Work Order ID 95037

Item Name: Replacement Skidtube

DESIGN		DART AEROSPACE USA, INC PORT HADLOCK, WA
DRAWN		
CHECKED		DRAWING NO. REV. A
MFG. APPR.		D3804 SHEET 1 OF 5
APPROVED		TITLE SCALE
DE APPR.		SKIDTUBE ASSEMBLY, 206A/B NTS
DATE	08.07.07

DRAWING NO.	TITLE	REV. A	DART AEROSPACE LTD	D.E.O. NO.	SHEET NO.	SCALE
D3804	SKIDTUBE ASSEMBLIES, 206A/B		ENGINEERING ORDER	D3804-A-1	SHEET 1 OF 1	NTS
DRAWN	CHECKED A.P.		MFG. APPR.	APPROVED	DE APPR.	
DATE 12.10.12	DATE 12.10.22		DATE 12.10.22	DATE 12.10.22	DATE 12-10-22

DETAIL B
AMENDMENT TO DETAIL B
NOT TO SCALE

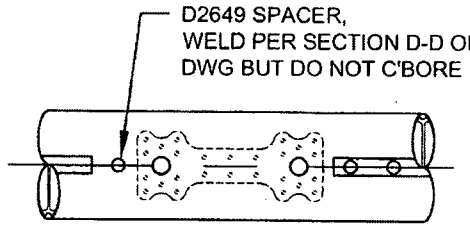
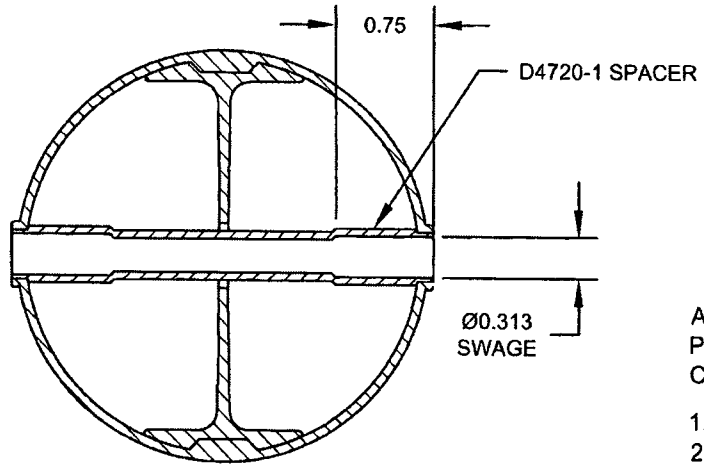
PURPOSE:
CHANGE C'BORED WELDED CROSSBOLT SPACERS TO SWAGED SPACERS

ADD SECTION H-H BELOW, WHICH IS THE SAME SECTION VIEW AS SECTION D-D OF DWG. **C'BORED** HOLES ARE **NOW SWAGED** PER SECTION H-H BELOW. FOR THE Ø0.375 HOLE THAT IS NOT C'BORED, WELD PER SECTION D-D OF DWG (SEE AMENDED DETAIL B FOR REFERENCE).

SECTION H-H
FOR Ø0.375 HOLES ONLY
FOR HOLES THAT ARE CURRENTLY C'BORED ONLY
NOT TO SCALE
